ROCHESTER PRESERVATION BOARD
STAFF REPORT
For hearing scheduled for July 6, 2016

A-050-15-16

123 S. Fitzhugh Street

Project Description: To install 26 solar panels on the west roof of the house.

Yearwood Solar Site Layout

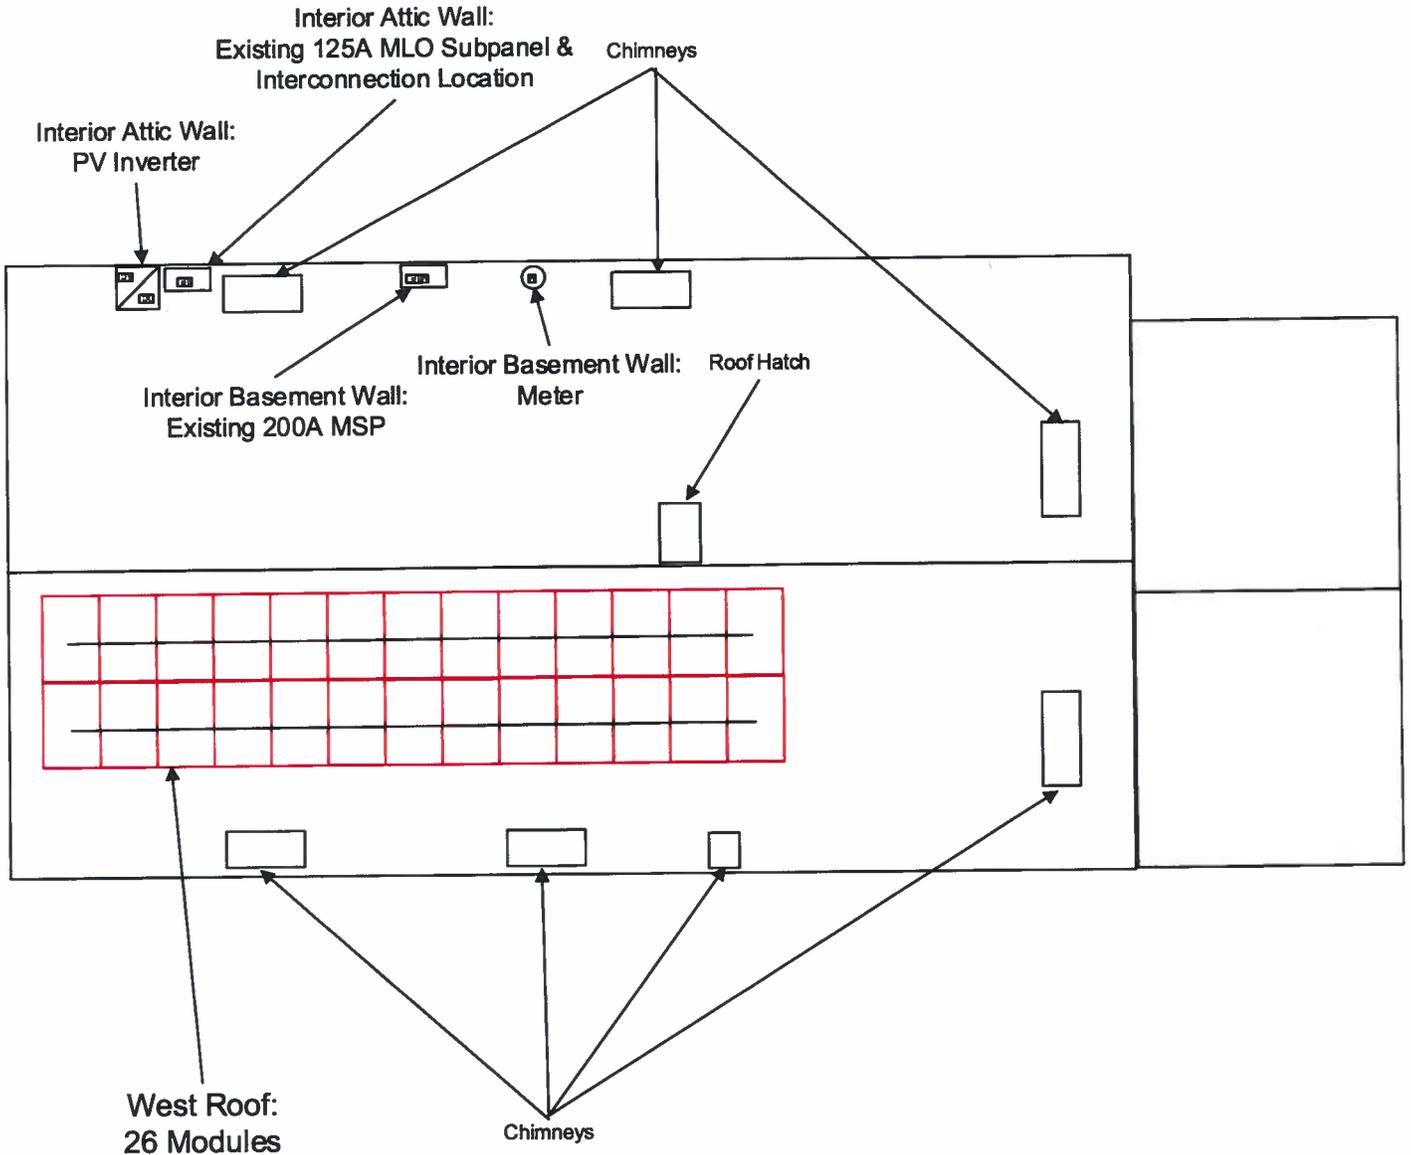
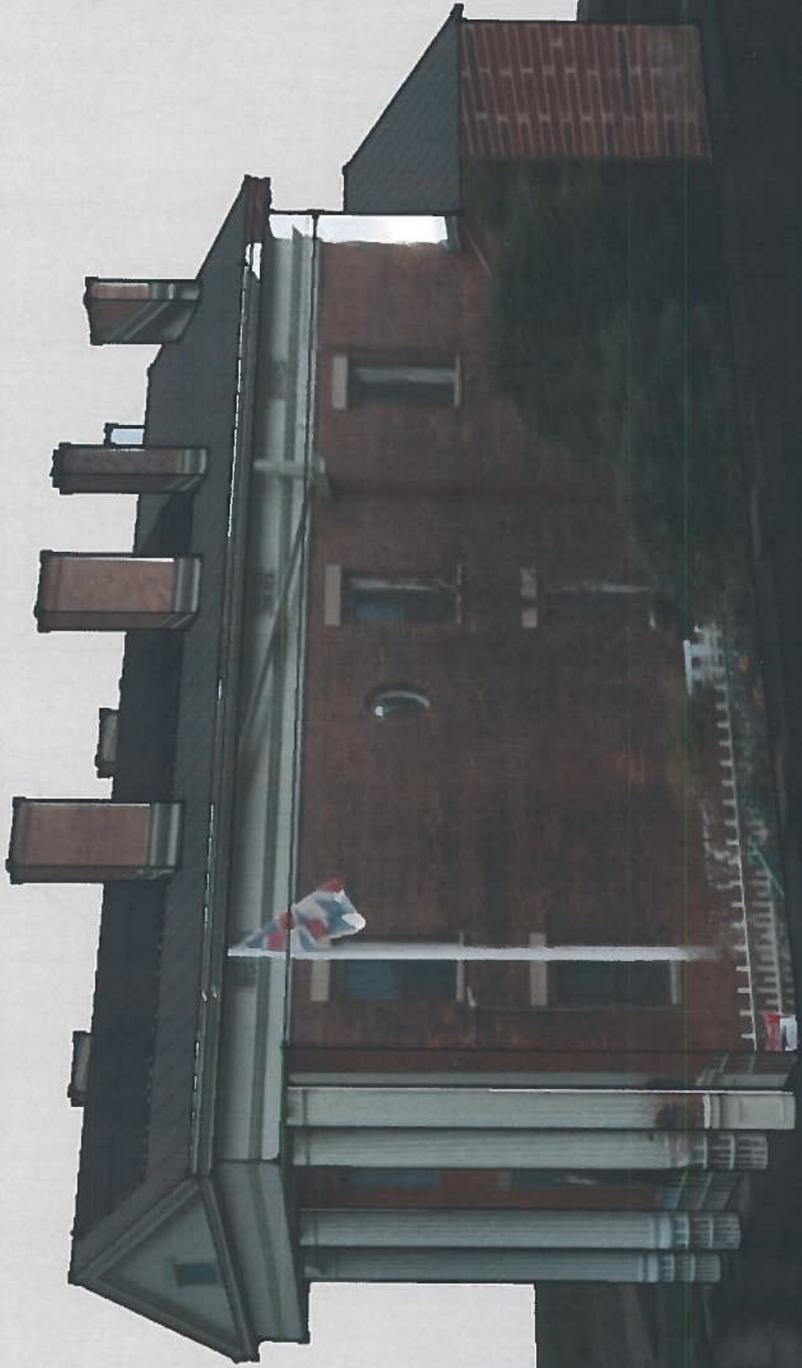
At the June 1, 2016 hearing of the Preservation Board, members expressed concern that the panels would be very visible on the light-colored roof, especially on the highly-visible east side, and that the mounting screws would penetrate terne copper roofing. Members suggested that the applicant consider installing panels on the rear, lower roof, which is not copper. The Board held its decision pending a redesign.

The new design places all 26 panels on the west-facing roof, which is largely hidden from view by adjacent buildings.

WEST ELEVATION

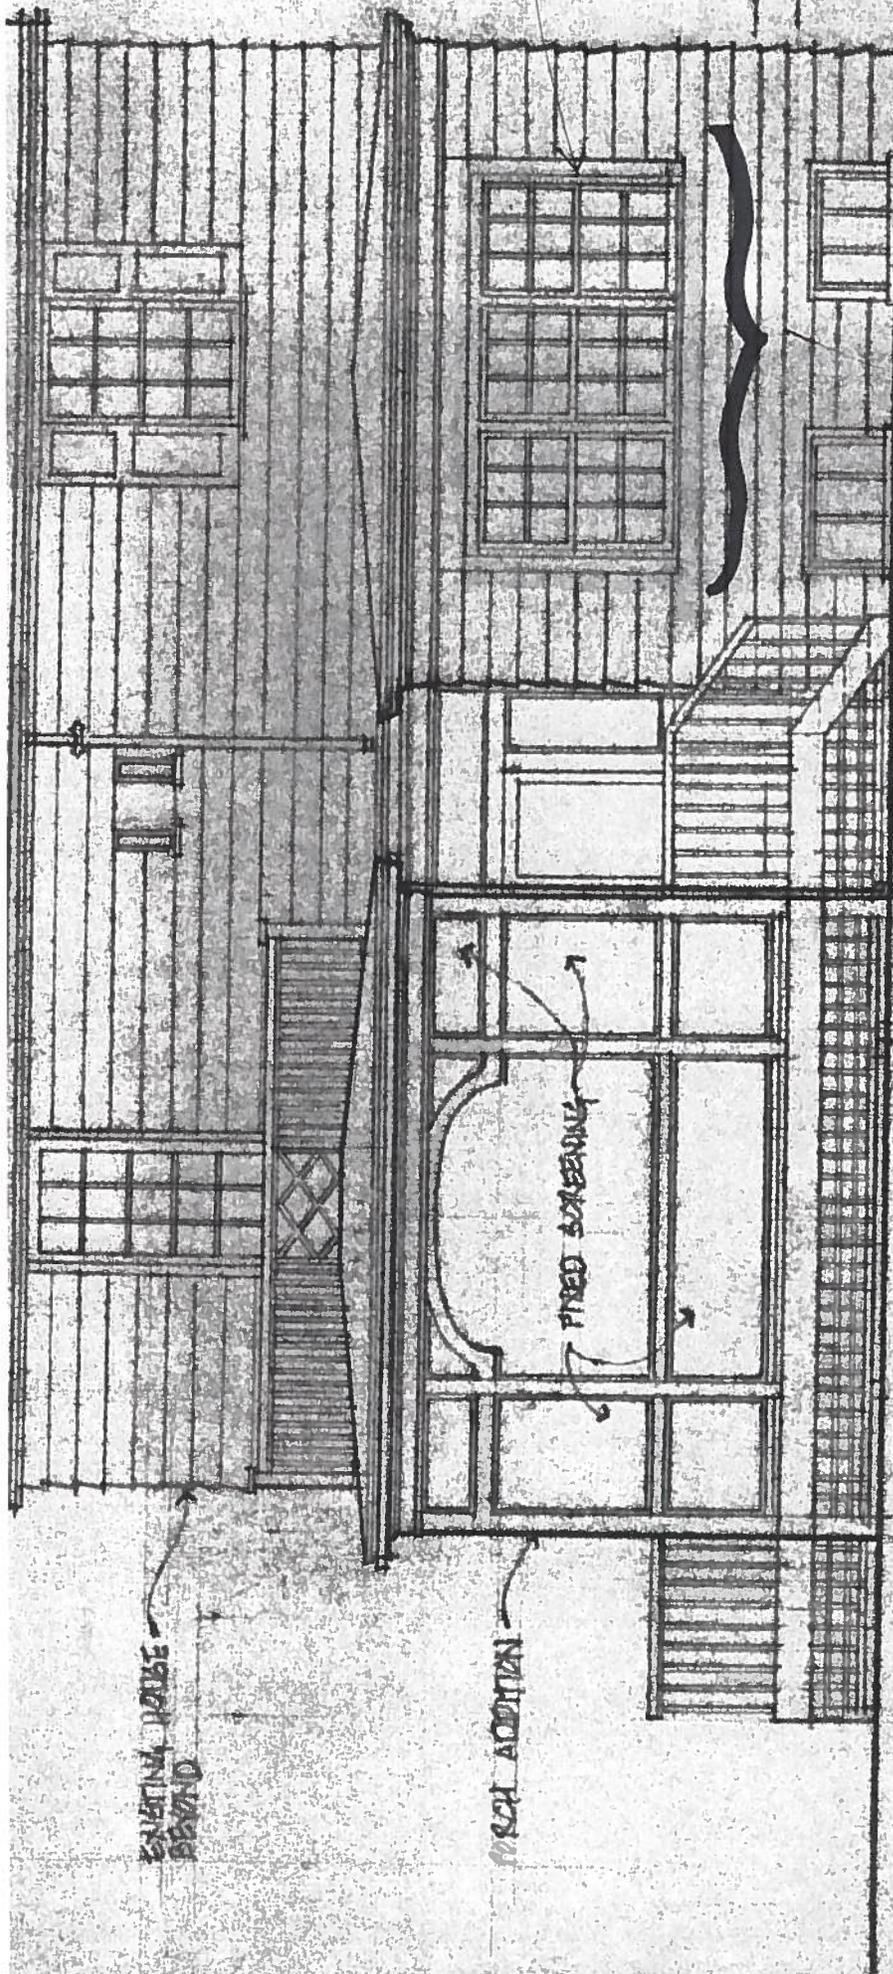
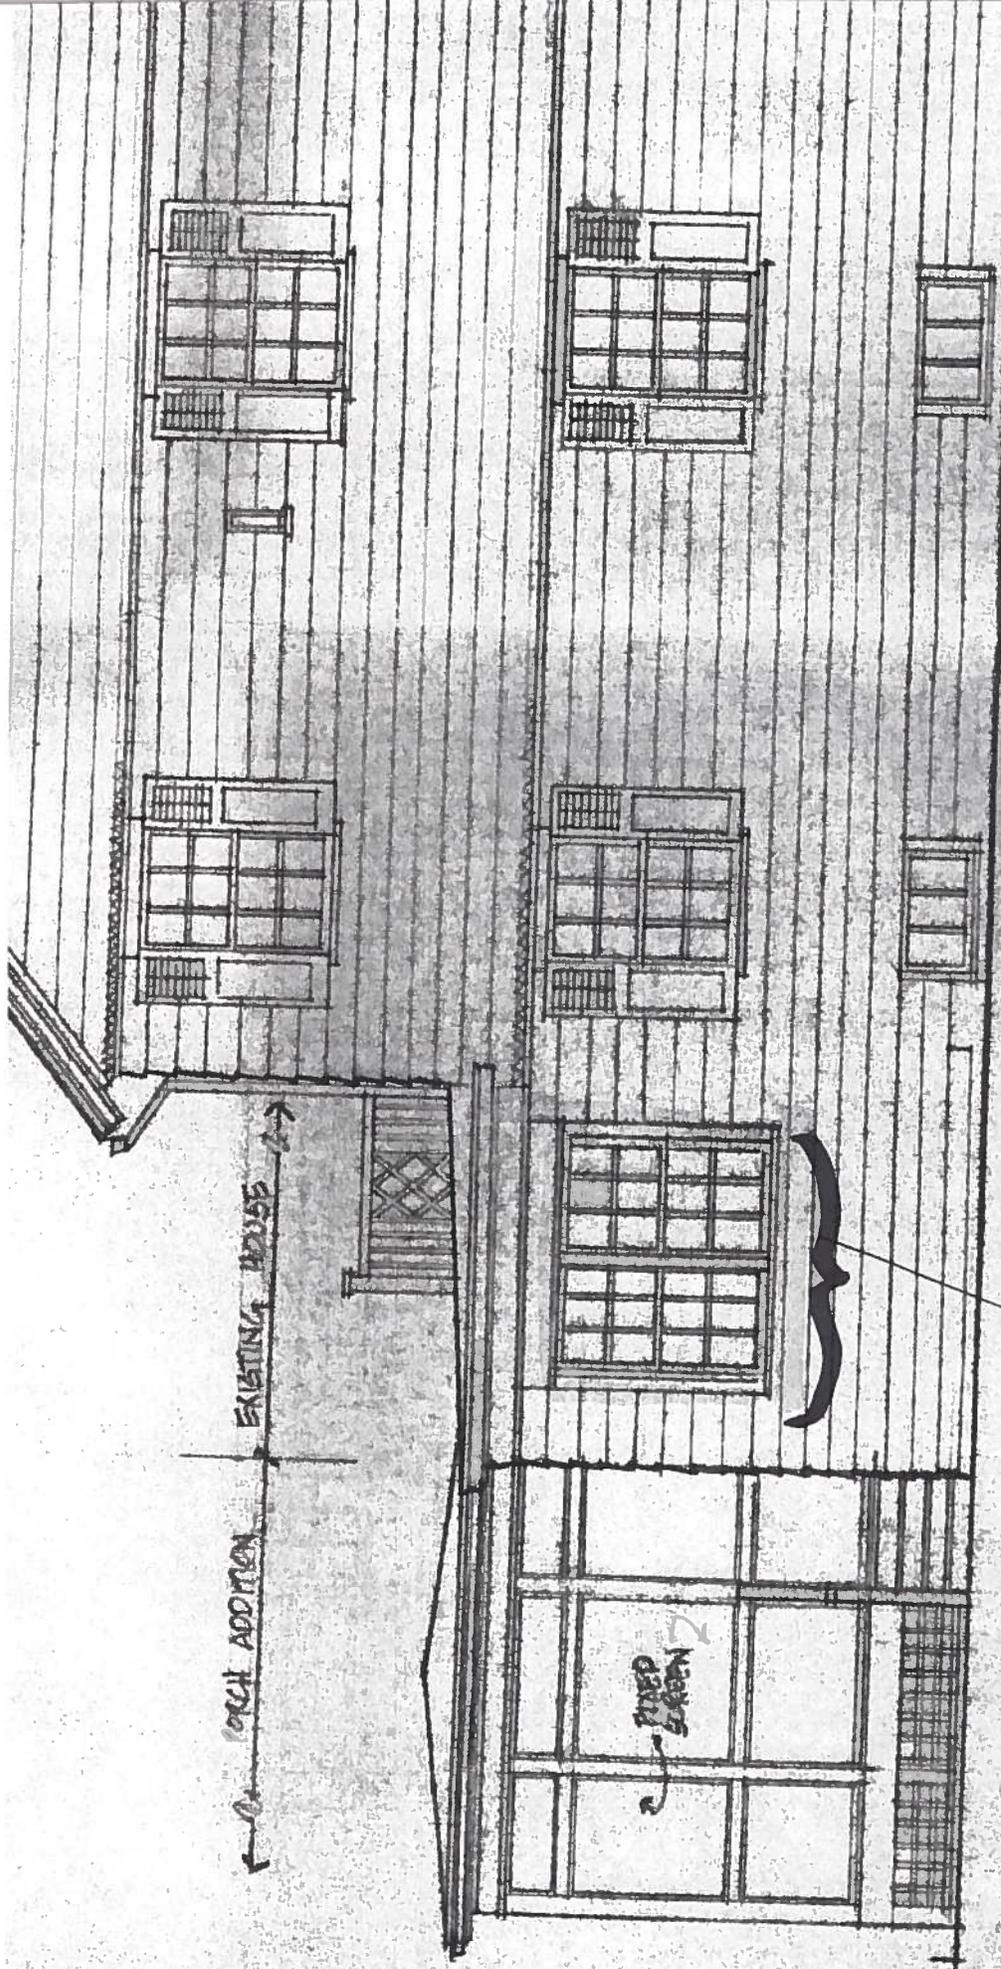
The replacement insert windows would be Marvin double-hung, wood with white aluminum cladding and simulated divided lites to match the existing muntin pattern.

Qty.(1) Double Sided Post & Panel Sign

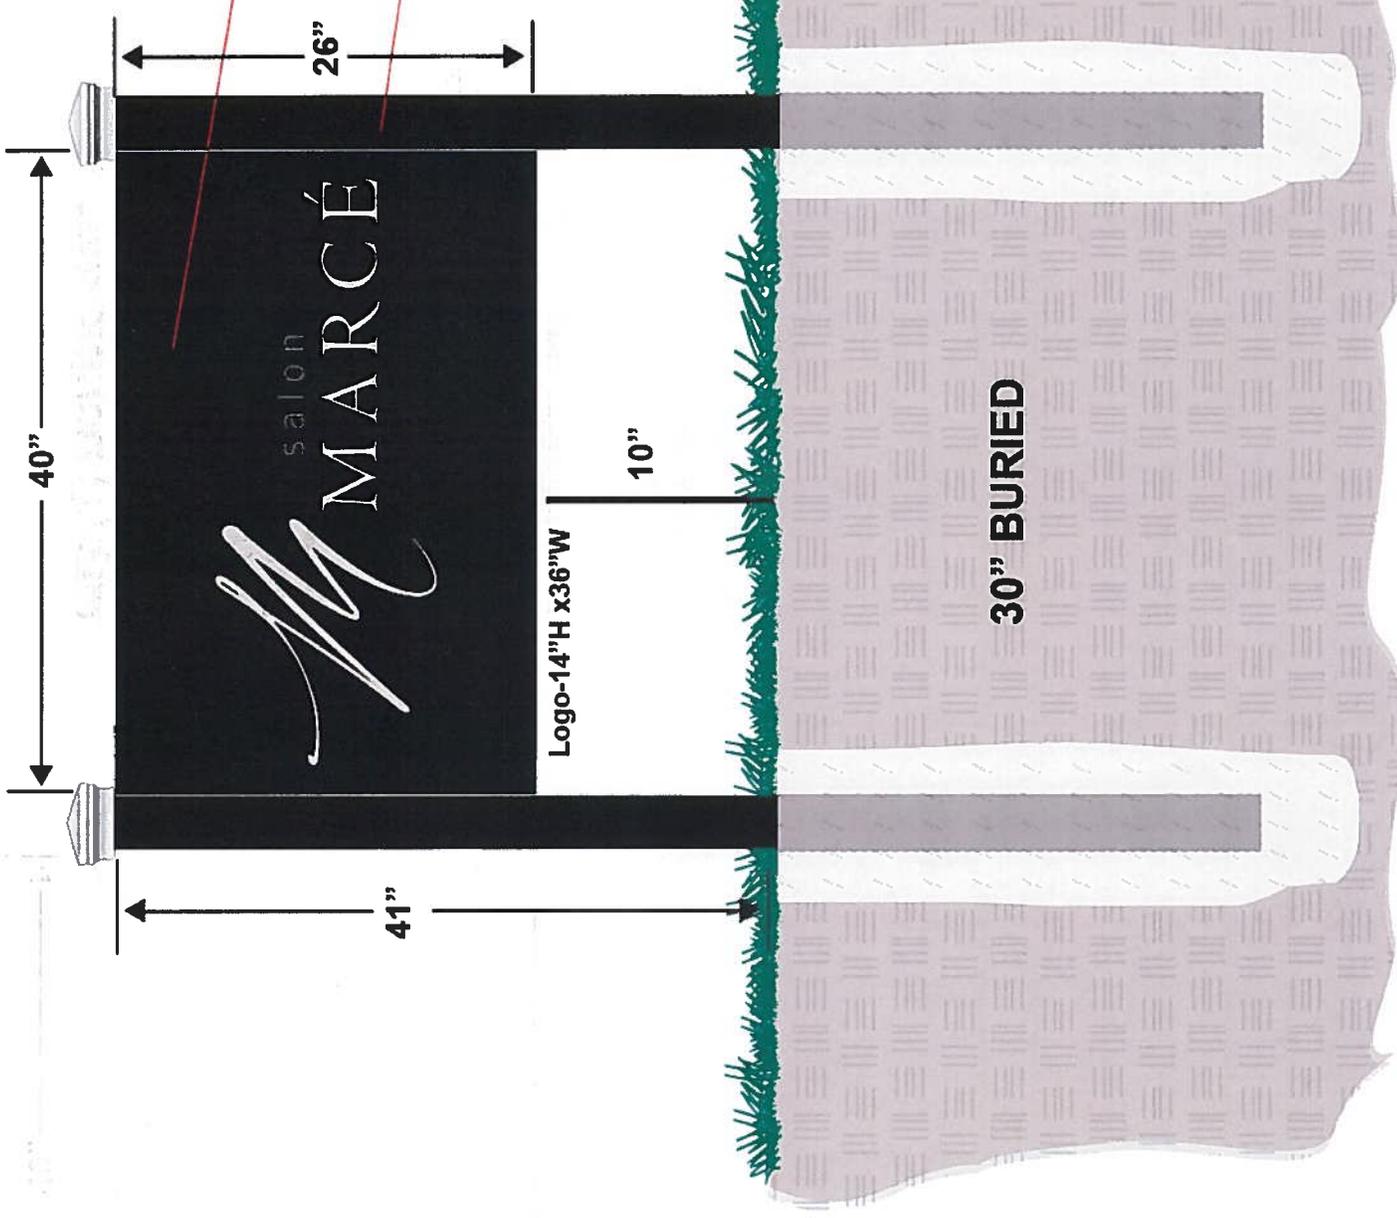
Ground signs in an R-2 zone are limited to 15SF and 4'-0" tall, although the Board may permit a larger, taller sign. This sign is compliant as shown.

Bistro Six30 Channel Letter Sign

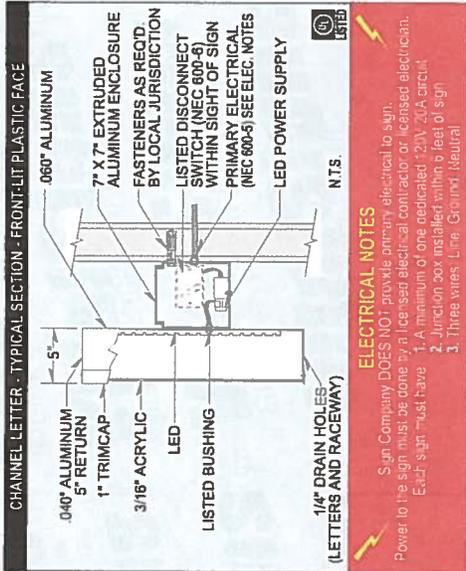
This sign is meant to align with, and fit the scale of, the other signs on the building. In Vital Signs' drawing, the grey box around the letters is just for contrast; you would see a 7" high raceway behind the letters, as shown in the section.

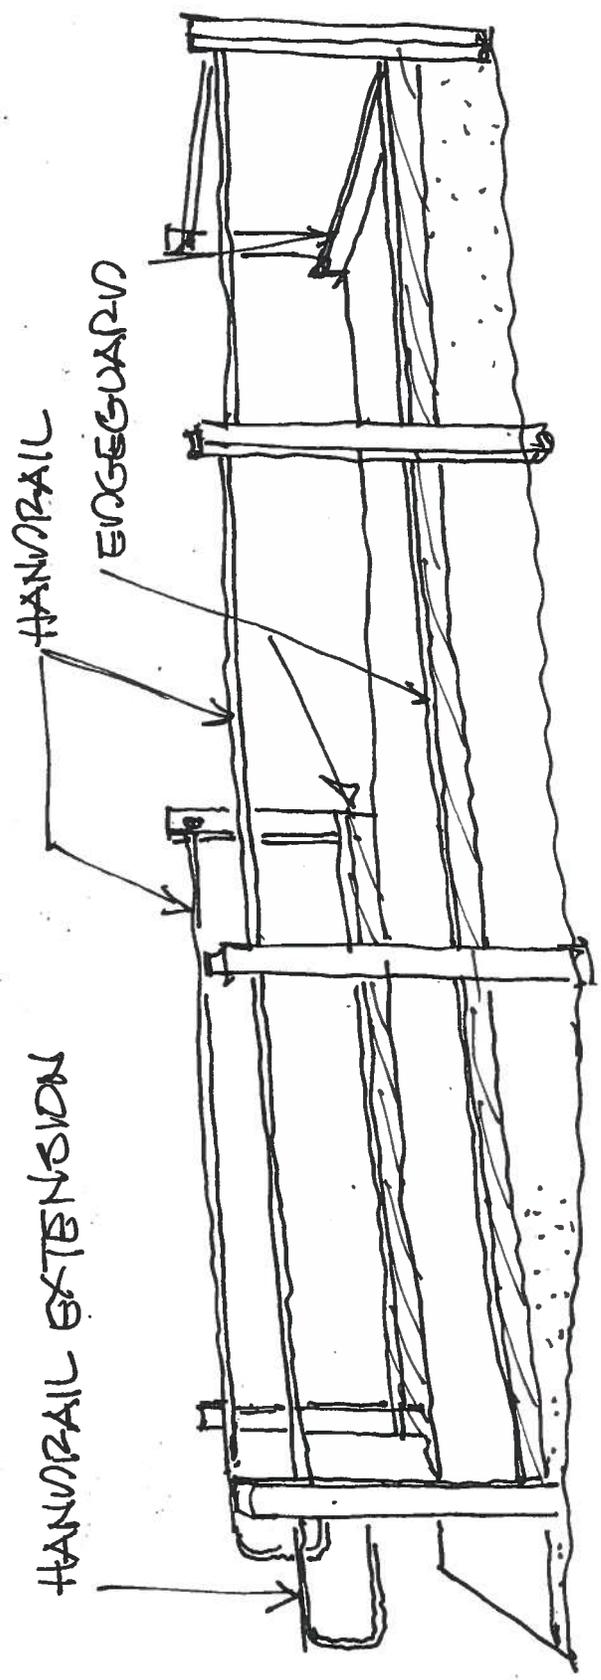
When the stairs, landing, roof and handicap lift were approved by the Board in 2015, the ramp was not part of the application. Following the approval, the applicant found that the vertical run of the specified lift was 8" shorter than the height of the landing, and the cost of a taller lift was far higher than constructing a ramp. He chose this latter route, but failed to obtain a building permit.

Per the NYS Building Code, any ramp rising higher than 6" needs a handrail and an edge guard on both sides. In this case, the ramp rises 8".

Note that the handrails on the steps are made of plumbing pipe, which is not what we expected when the stairs were approved. We're working on this.

Enclosed is a rough sketch from staff showing a resolution:

1. Keep the wood posts;
2. Remove the wood railings;
3. Reinstall the lower railings to act as edge guards, which are meant to prevent a wheelchair from running off the edge, and to provide a tapping surface for a walking stick.
4. Install handrails. These must extend beyond the end of the ramp, and return back to the posts.
